ADDENDUM NO. 1

PROJECT NAME: BARBARA DRIVE DRAINAGE PROJECT (McCULLOUGH AVE TO SKIPPER DR)

DATE: 01/12/2017

TCI PROJECT NO.: 23-01398

CHANNEL WINGWALL EXTENSION DETAIL

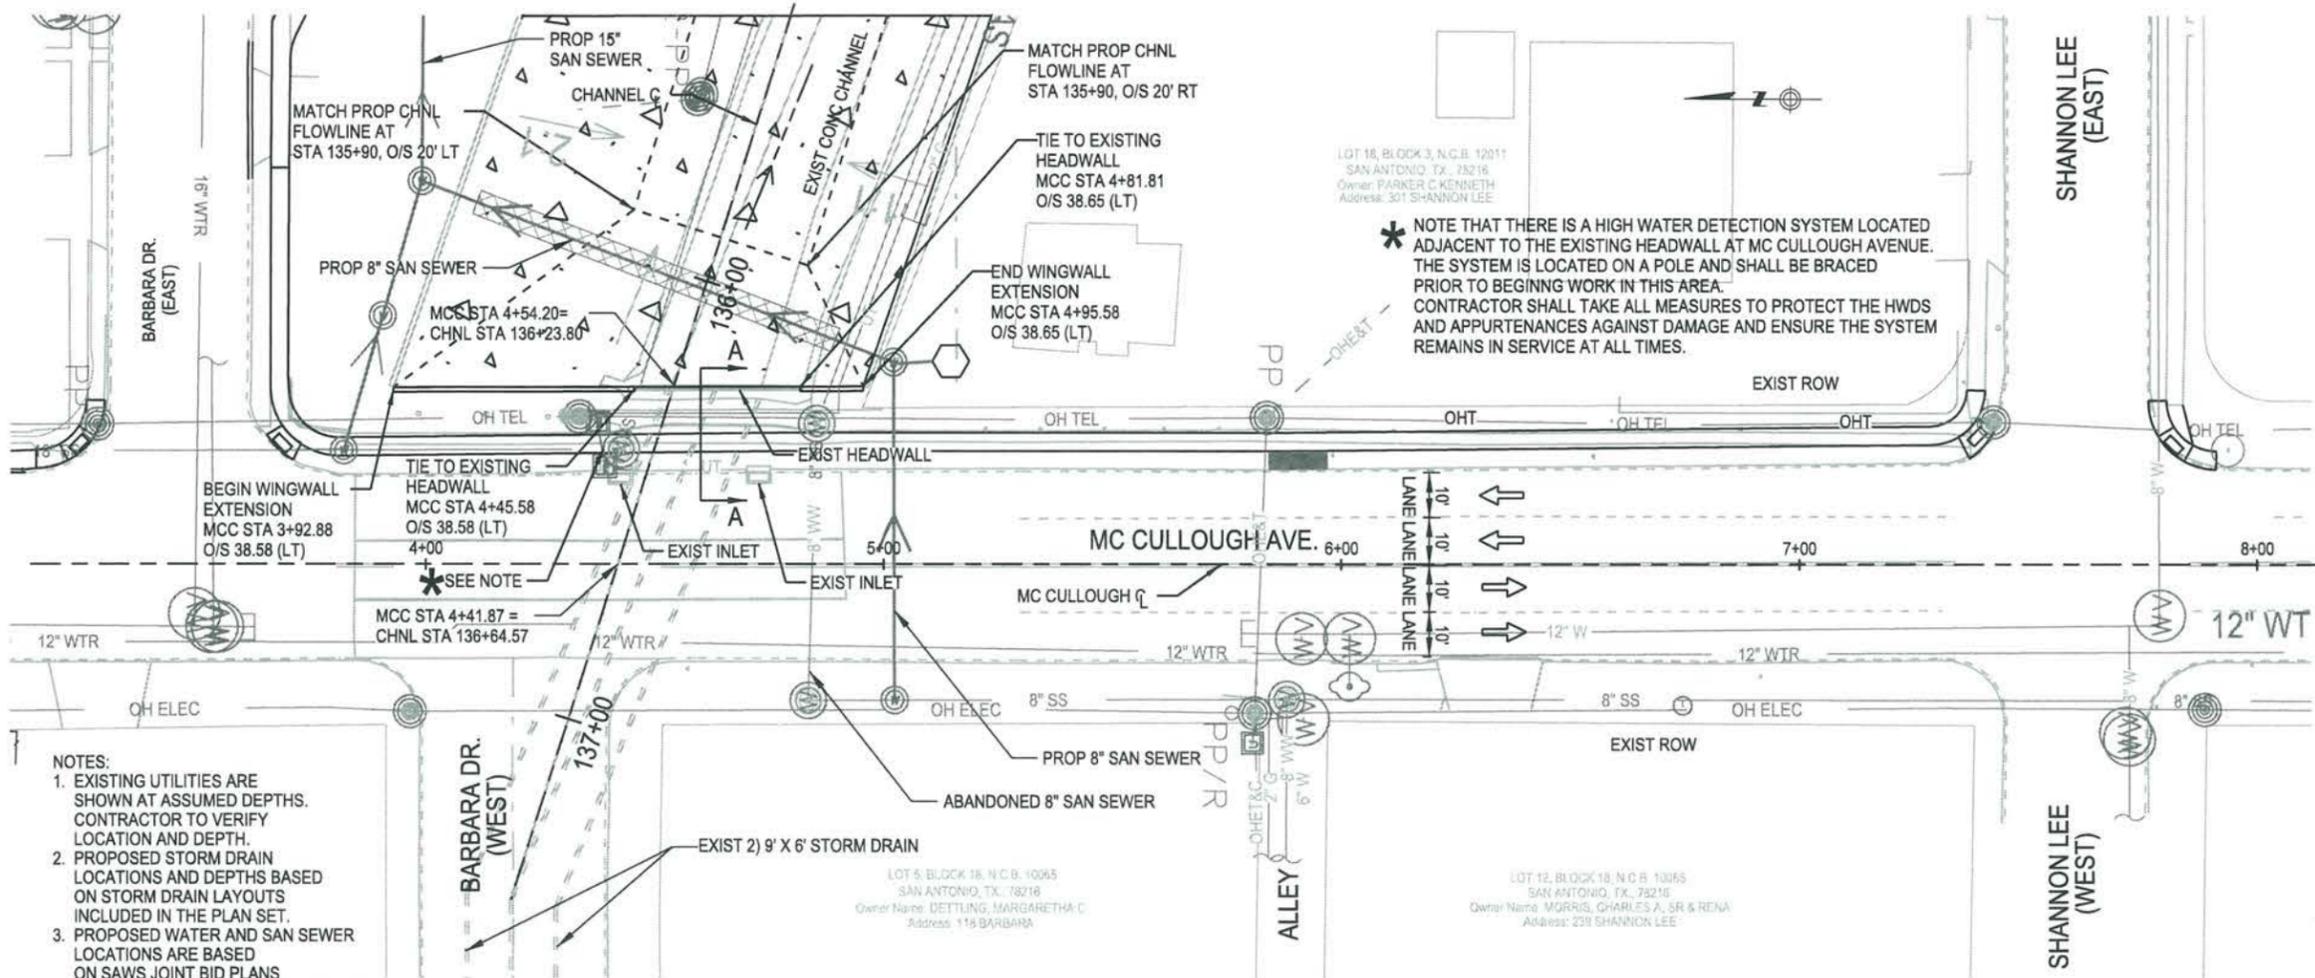
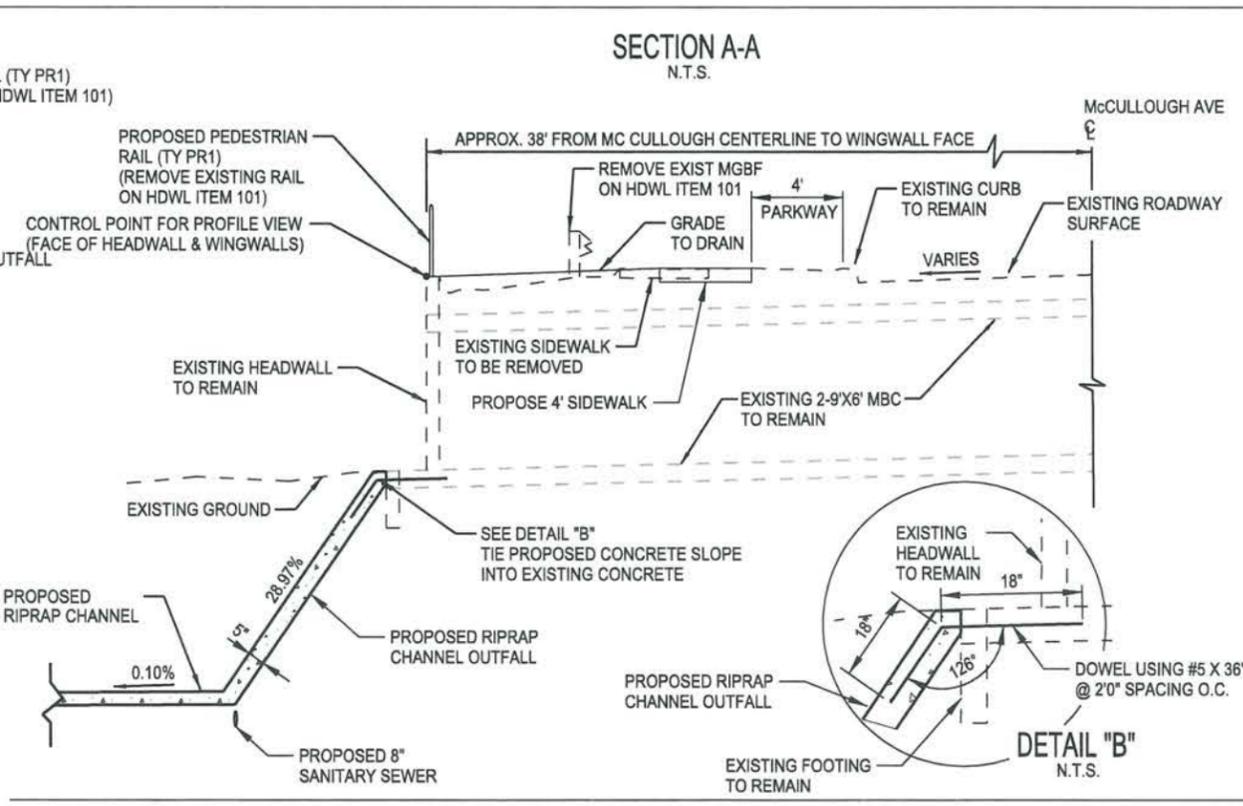
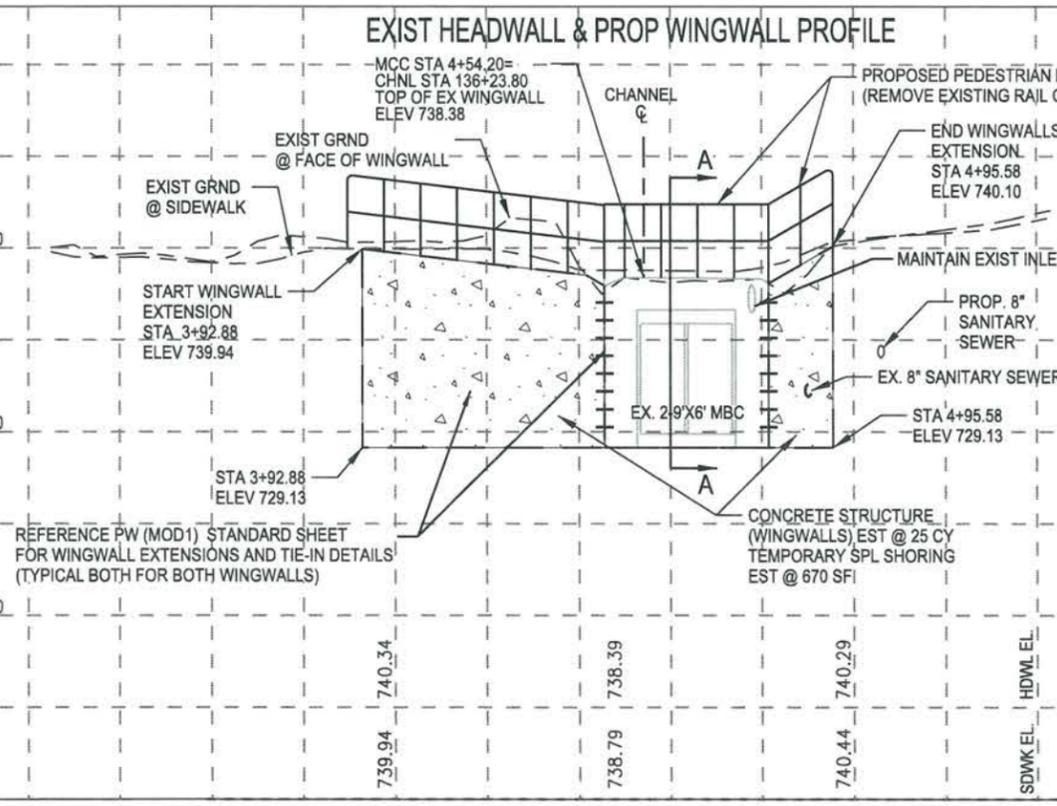
11. Substitute and utilize updated “Channel Wingwall Extension” (Sheet No. 70) revised to clarify location of existing High Water Detection System at McCullough Avenue, and add notes regarding requirements for utility bracing and protection of the System against damage for continued operation at all times during construction.

SUBMITTAL	PROJECT NUMBER	DATE
100%	E0384400	1/12/2017
DRWN BY: EV	DSGN BY: KS	CHKD BY: MB
		SHEET NO. 102

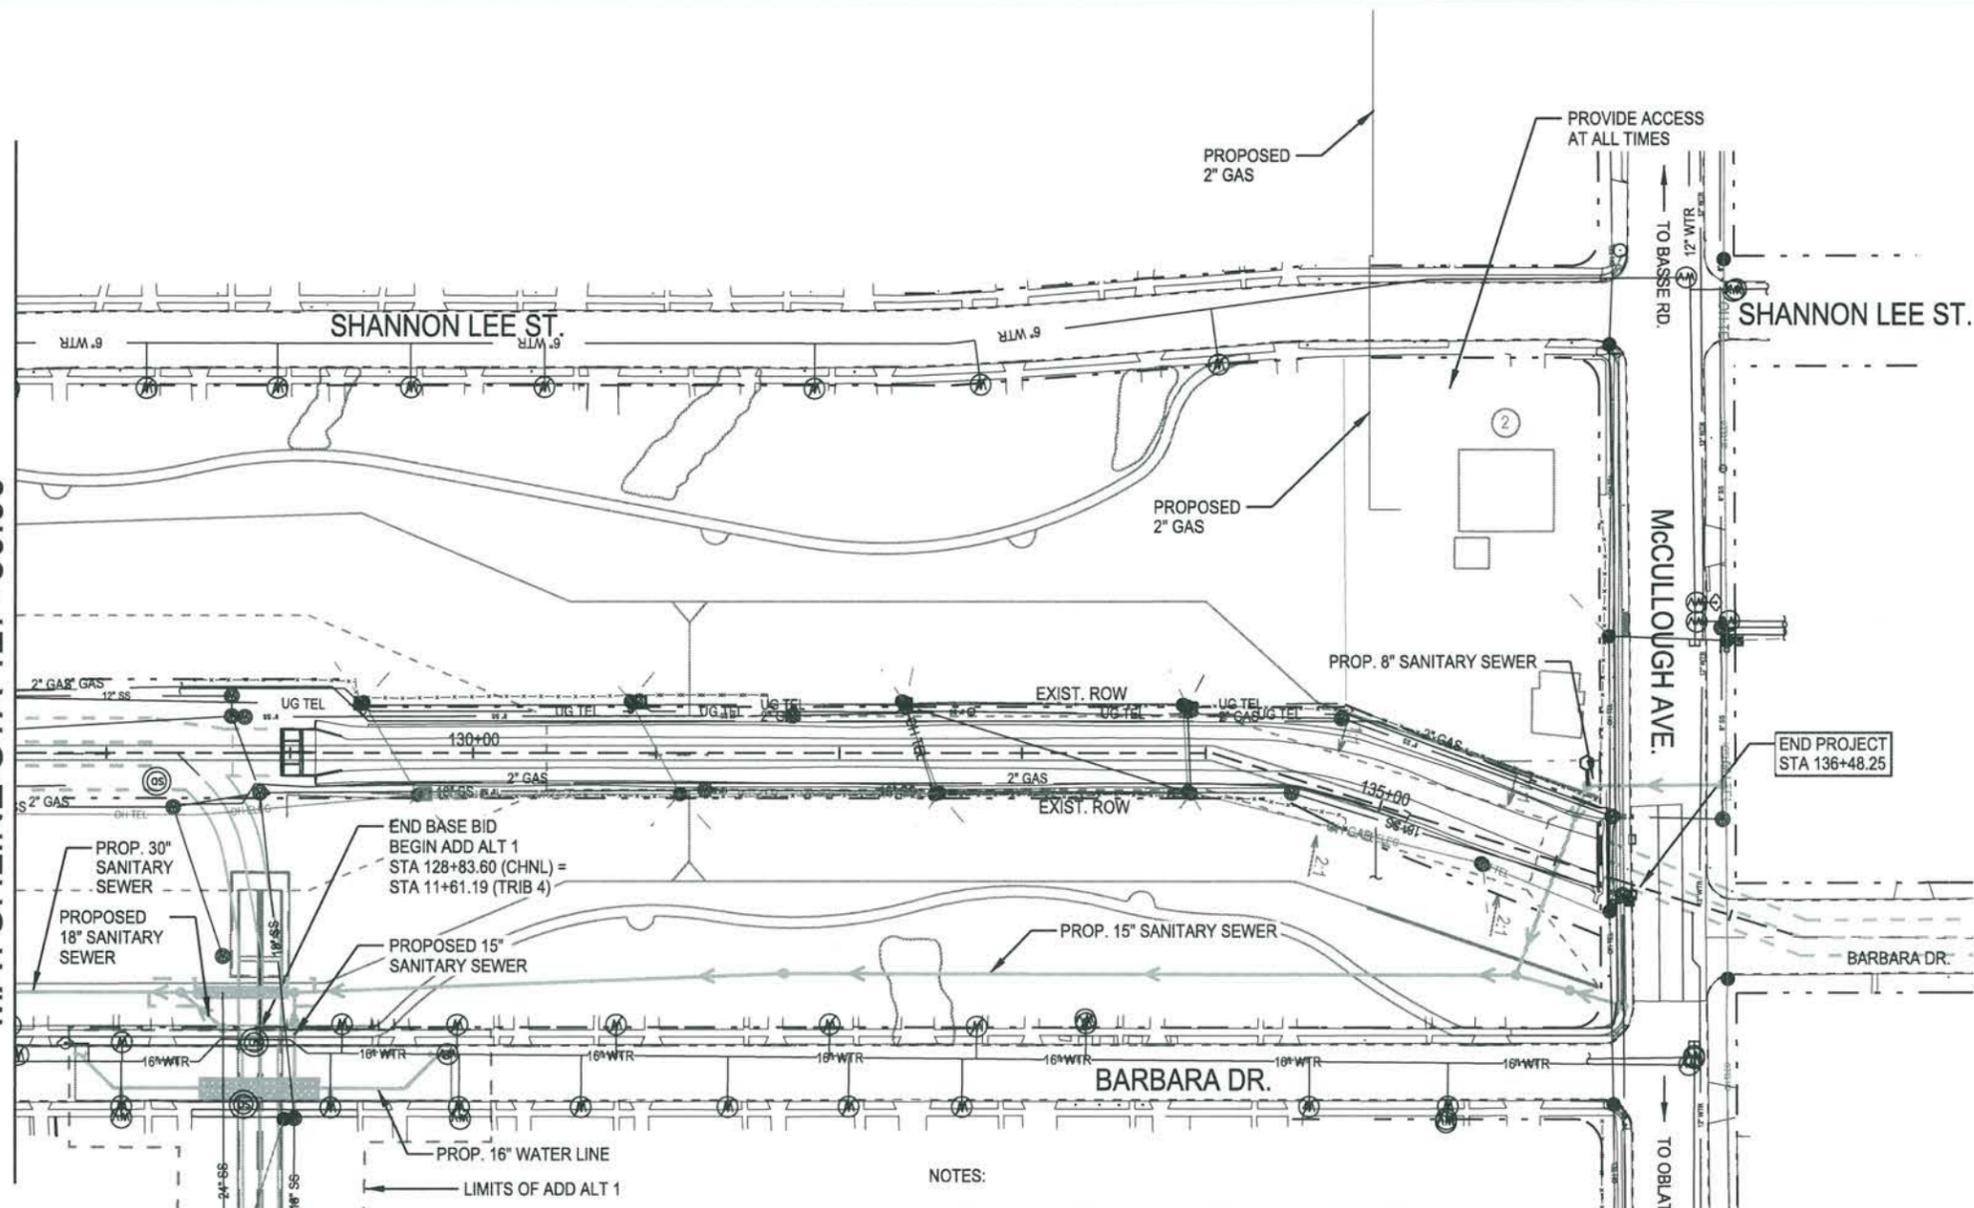
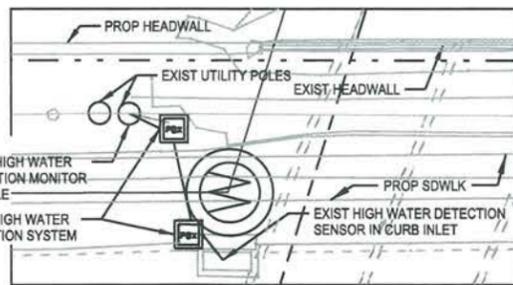
12. Substitute and utilize updated “Existing & Proposed Utility Layout” (Sheet No. 102) revised to include show existing High Water Detection System, protection notes and utility bracing requirements.

DETAIL "A"
EXIST HIGH WATER DETECTION LOCATION

Bridge Division Standard	
<h2>PEDESTRIAN RAIL</h2>			
<h3>TYPE PR1</h3>			
FILE: r1std028.dgn	DN: TxDOT	CK: TxDOT	DW: JTR
©TxDOT July 2014	CONT	SECT	JOB
REVISIONS			
DIST	COUNTY	SHEET NO.	
SAT	BEXAR	108A

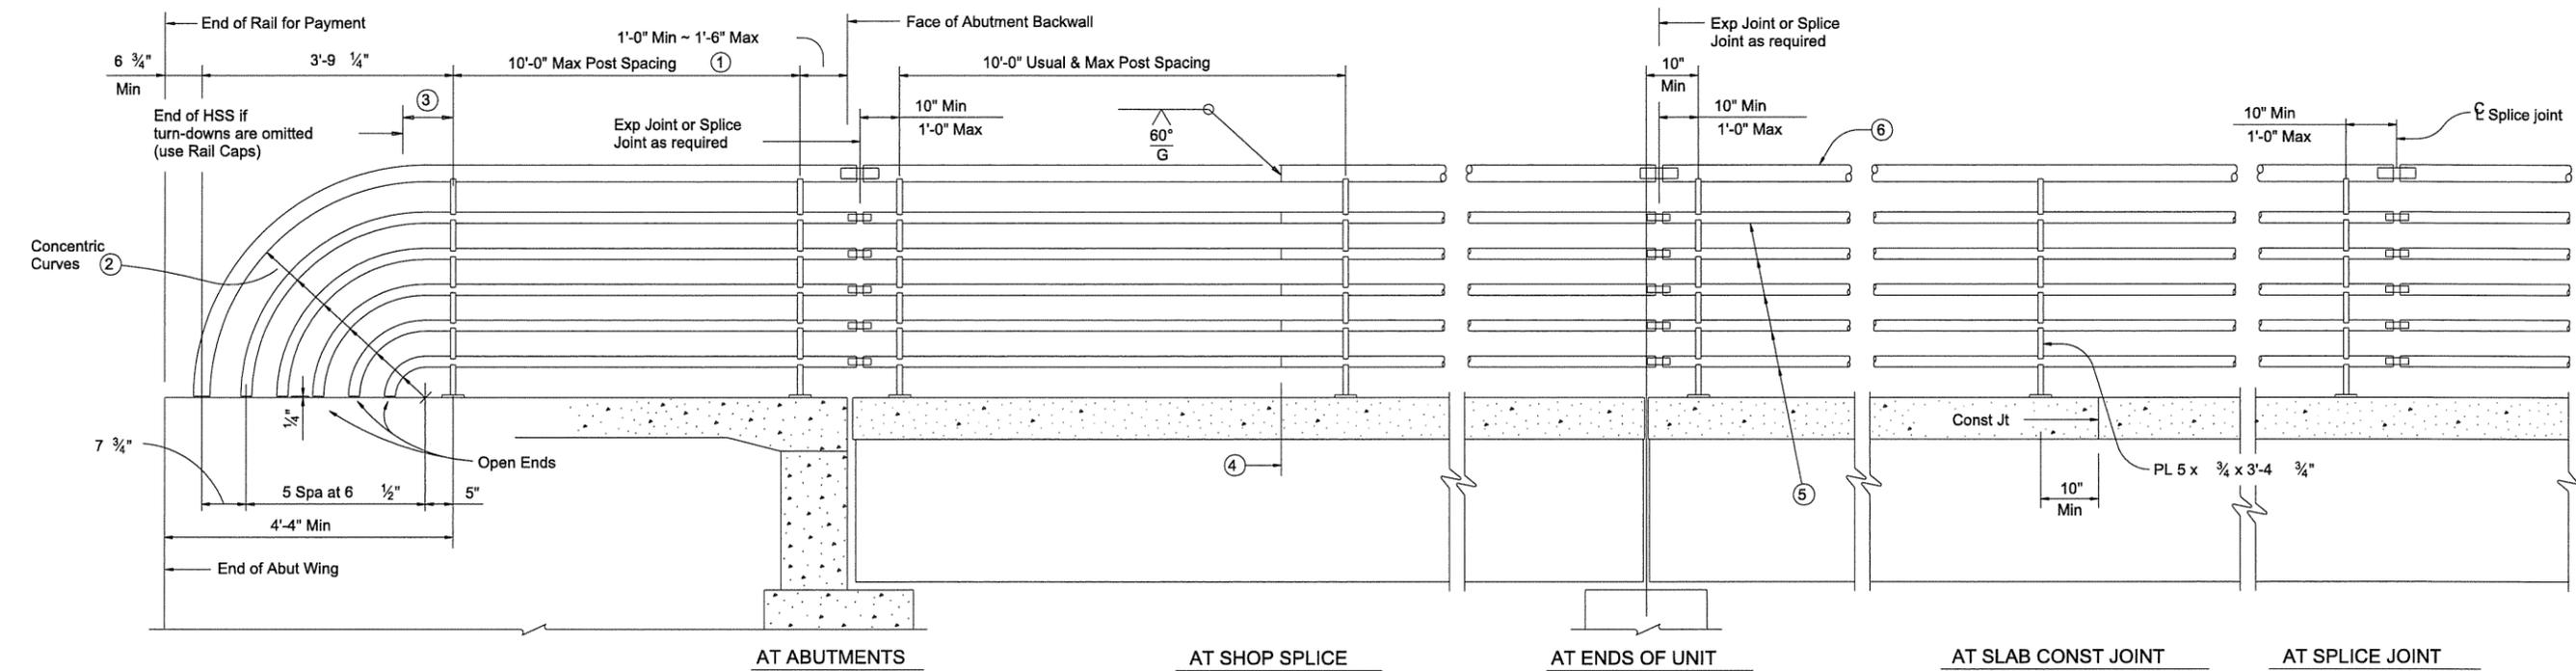
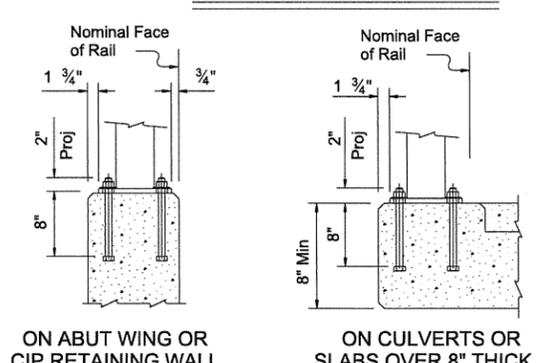
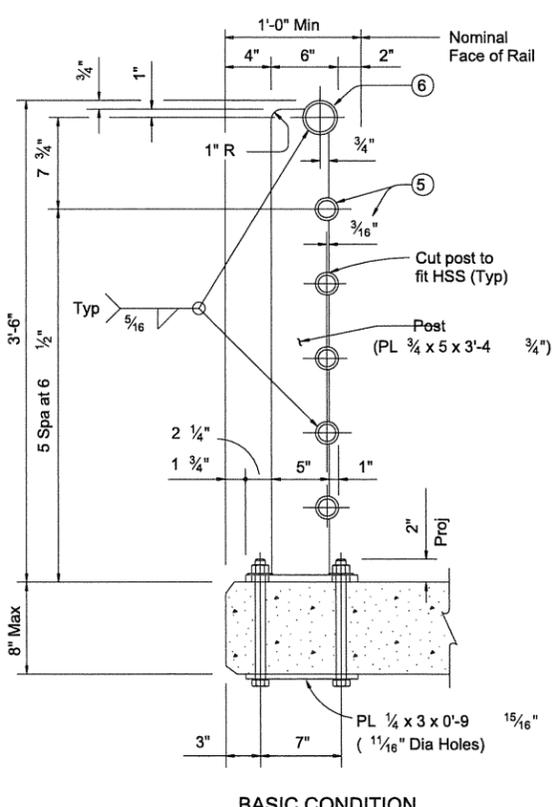
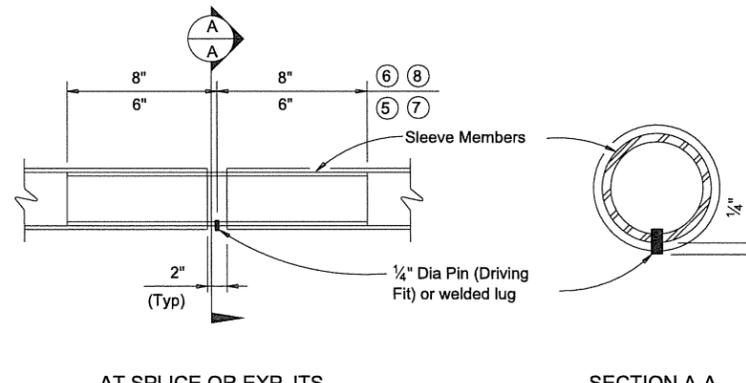
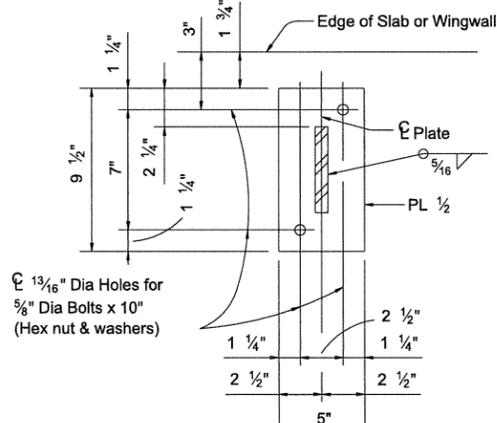
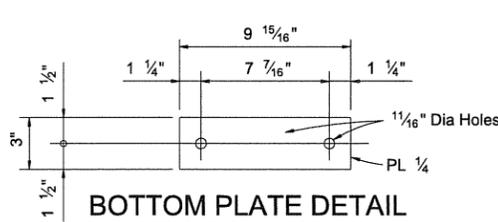
13. Added TxDOT Standard Specification “Rail (Type PR1)” designated as Sheet No. 108A.

2. Pedestrian Rail at McCullough Headwall –
 - a. *Anticipate reissuing plan sheets to incorporate change to the pedestrian rail type on the culvert headwall located at McCullough Avenue.*
